PRODUCT/PROCESS CHANGE NOTICE (PCN)

PCN #: **TB1503-01** DATE: **July 22, 2015**
 Product Affected: **TSSOP-20, TSSOP-24, TSSOP-28,**
 TSSOP-48, TSSOP-56, TVSOP-48
 SOIC-28, SSOP-20, SSOP-28,
 (Refer to Attachment II for affected part# shipped in Reel)
 Date Effective: **November 2, 2015 Earliest Date - Refer to**
 specific date by package type

Detail of Change: This notification is to advise our customers that IDT has planned to standardize the carrier tape on the selective package types to only one type as detailed below.

Illustration of Carrier Tape Pocket Design Change

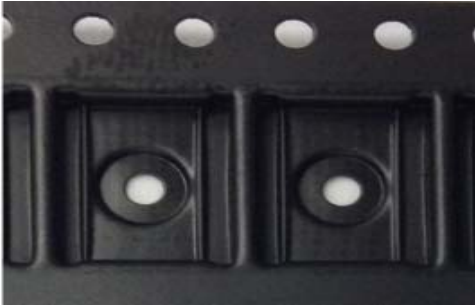
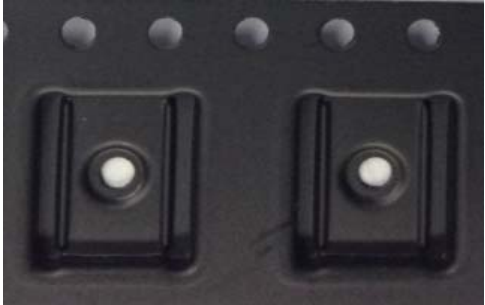
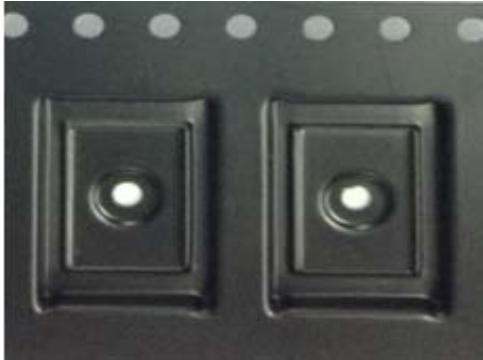
Package	From	To
TSSOP-20	Carrier Tape Part# P8-464-000 	Carrier Tape Part# P8-291-P20 
TSSOP-24	Carrier Tape Part# P8-329-P24 	Carrier Tape Part# P8-169-P24 
TSSOP-48	Carrier Tape Part# P8-260-P48 	Carrier Tape Part# P8-324-P48

Illustration of Carrier Tape Pocket Design Change

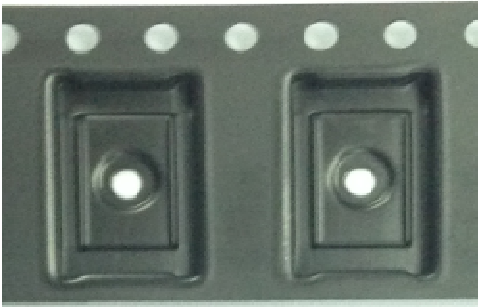
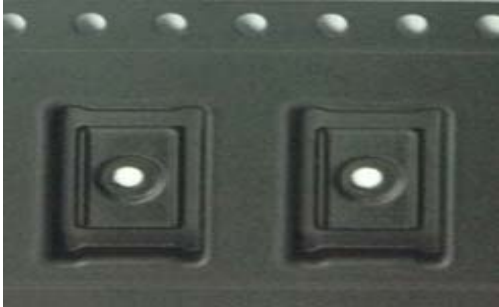
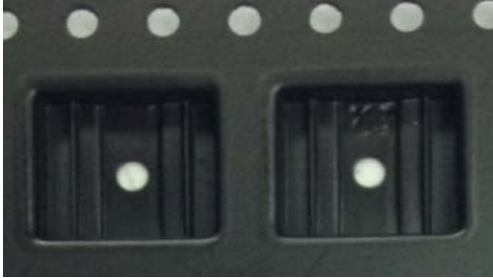
Package	From	To
SOIC-28	Carrier Tape Part# P8-187-S28 	Carrier Tape Part# P8-370-P28 
TSSOP-28 and TVSOP- 48	Carrier Tape Part# P8-145-PF8 	Carrier Tape Part# P8-330-P48 
TSSOP-56	Carrier Tape Part# P8-261-P56 	Carrier Tape Part# P8-314-P56

Illustration of Carrier Tape Pocket Design Change

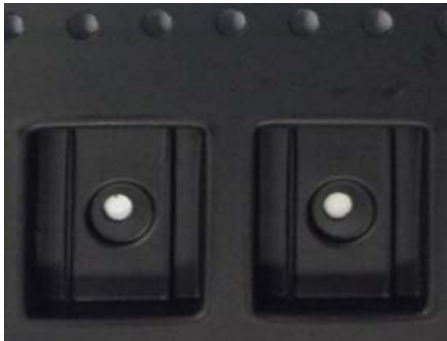
Package	From	To
SSOP-20	Carrier Tape Part# P8-259-P20 	Carrier Tape Part# P8-320-P20 
SSOP-28	Carrier Tape Part# P8-384-P28 	Carrier Tape Part# P8-321-P28
